**ITEM FOR ENVIRONMENTAL COMMISSION AGENDA**

Case Number: **1881 Westlake Drive SP-2021-0349D**

Variance Request: **LDC 25-8-281(C)(2)(b) - To allow construction within 150 feet of a Rimrock Critical Environmental Feature (CEF) .**

## **ENVIRONMENTAL COMMISSION MOTION 20220518 004a**

**Figure 4: Critical Environmental Features and Well Locations**  
1881 Westlake Dr.

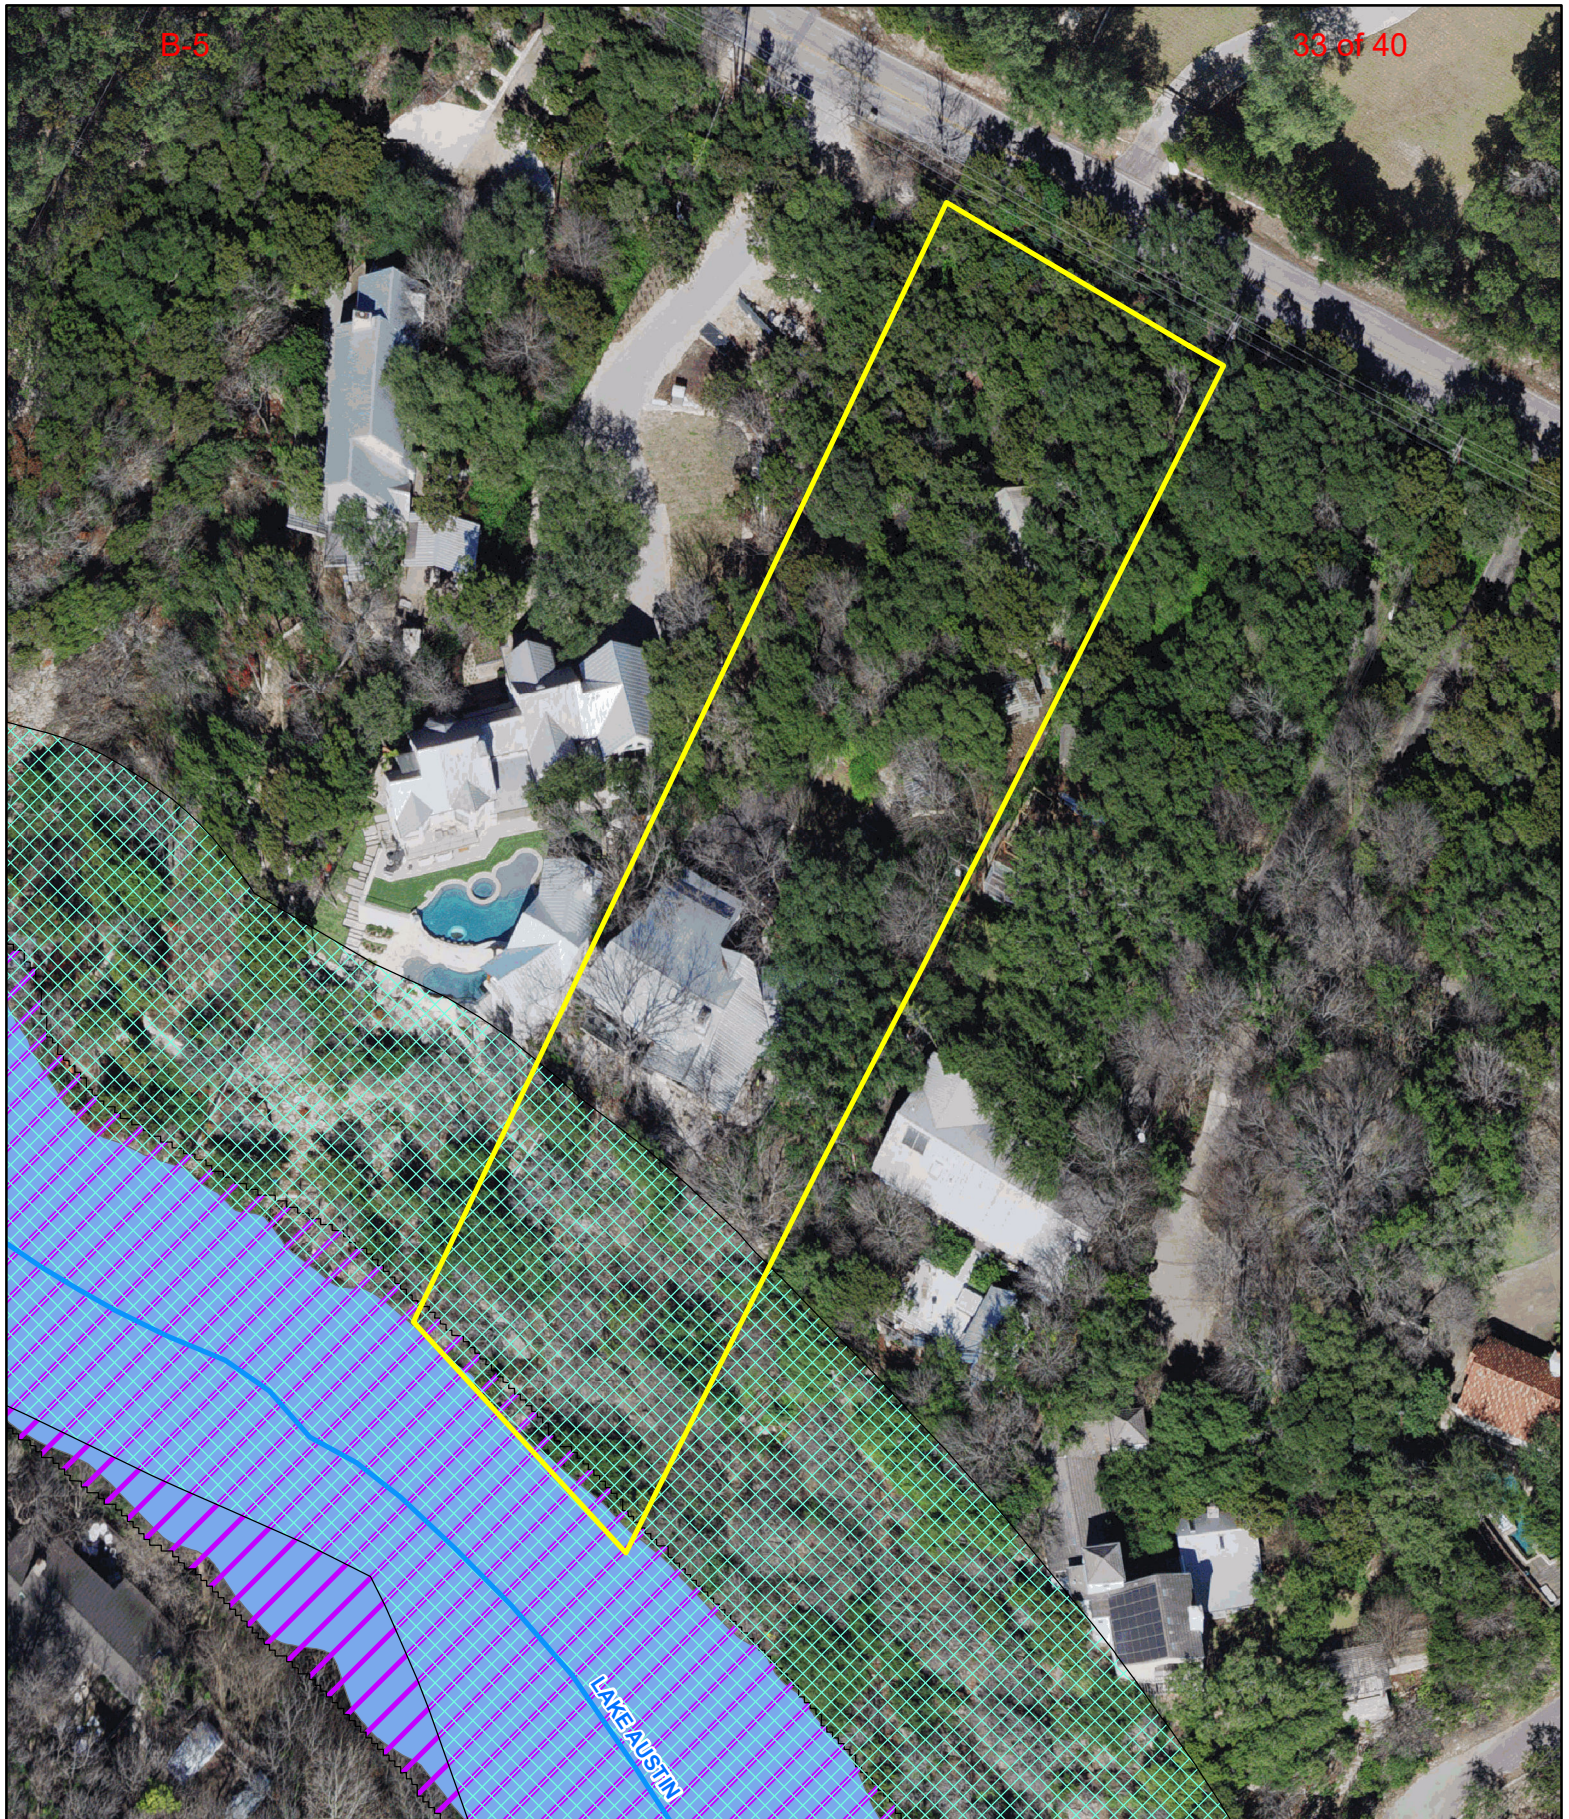
**YES. None of the rimrock CEFs are in the LOC, and mulch sock and floating silt screen will be deployed to contain all sediment within the LOC. Post construction, all disturbed areas will be revegetated per the COA 609S specification.**
